SEWAGE DISPOSAL SYSTEM

DEPARTMENT OF HEALTH AND MENTAL HYGIENE

HOWARD COUNTY HEALTH DEPARTMENT

REPAIR - PURPOSE - REPLACE COLLAPSED METAL TANK.

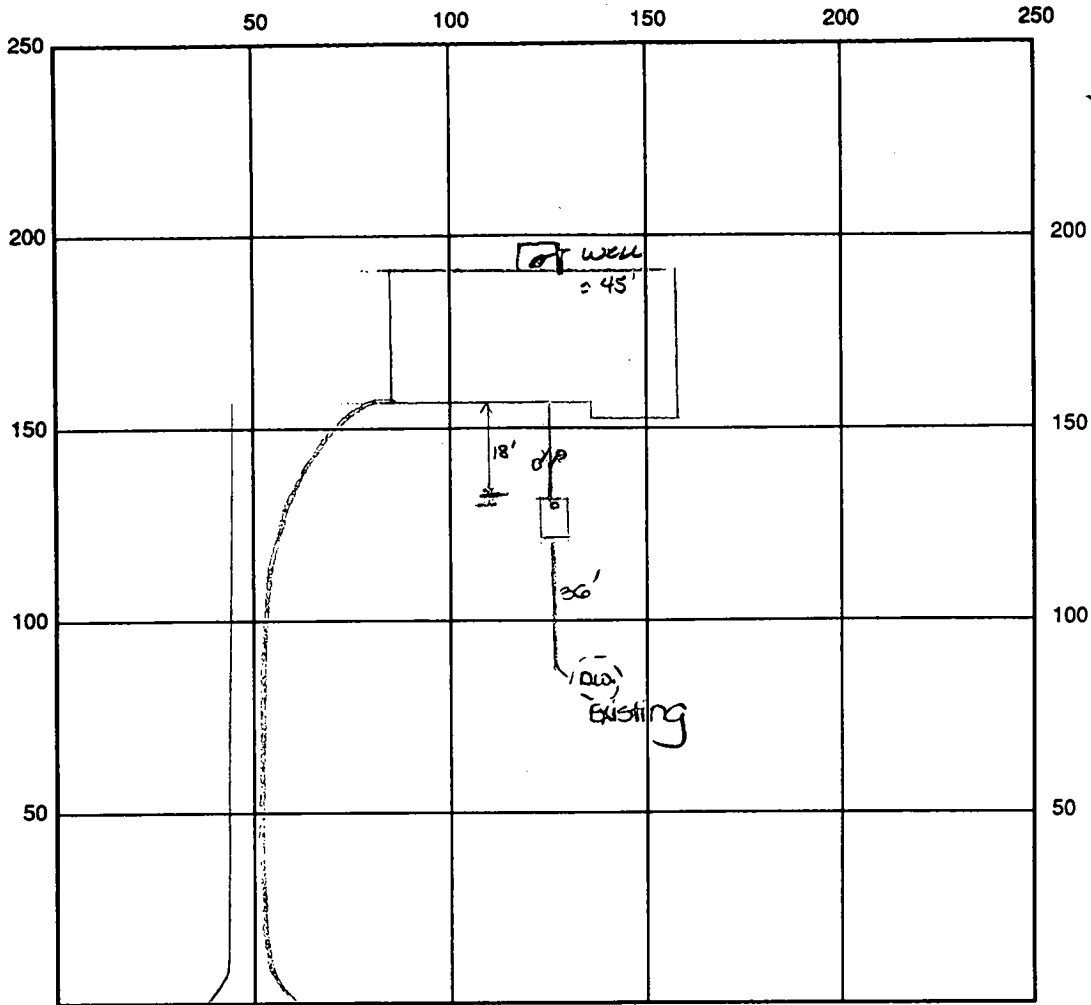
SEPTIC TANK LEVEL OK - 1000 gal CLEANOUTS two at house, one on s.t.

REMARKS: 8/19/96 FINAL - OK to cover septic tank and
line. Existing drywell OK, no sign of failure at this
time. DKS

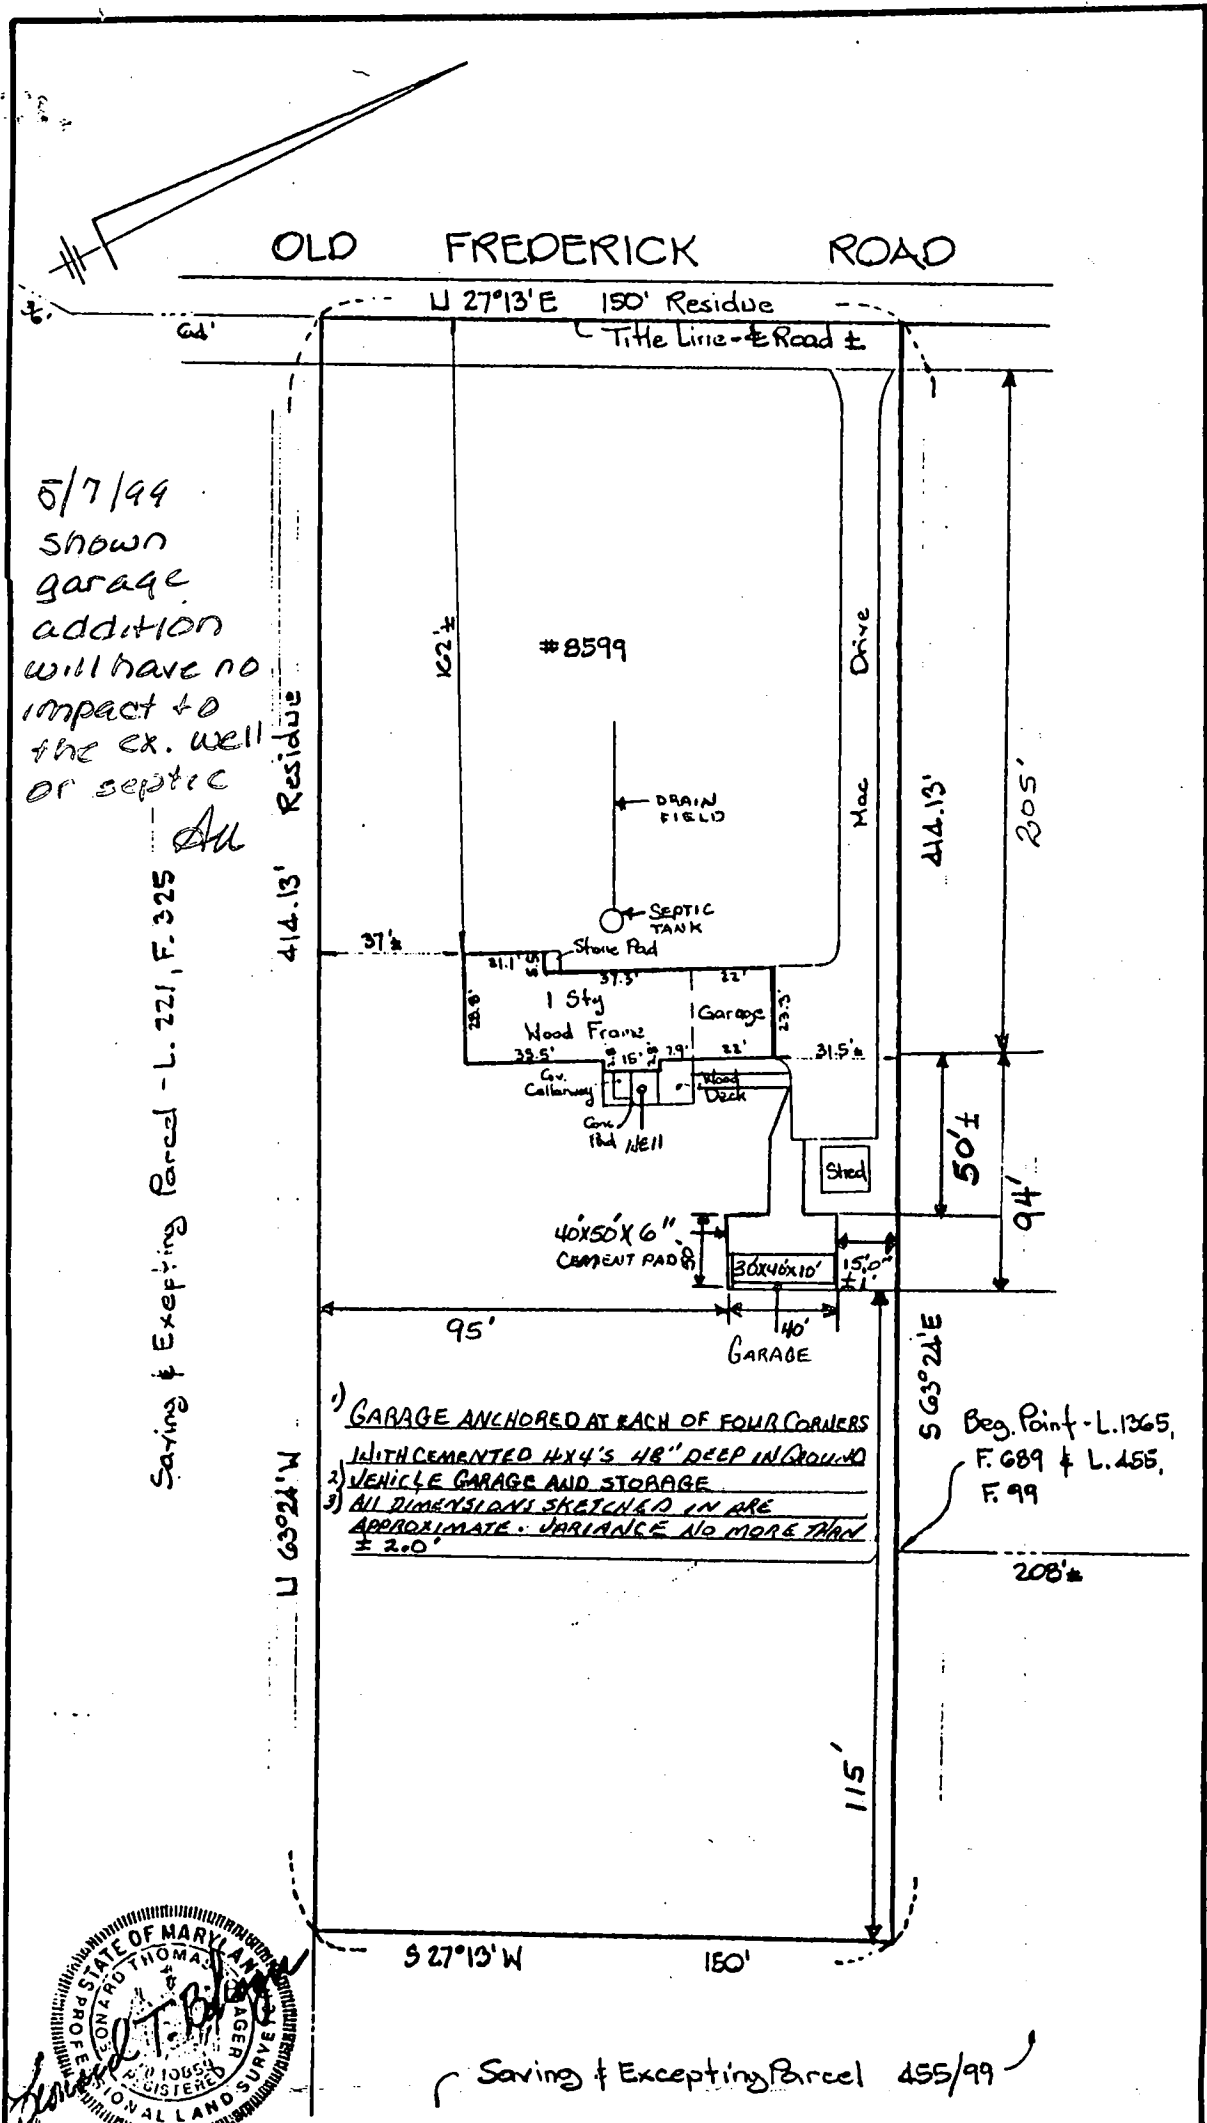
5/7/99
 shown
 garage
 addition
 will have no
 impact to
 the ex. well
 or septic
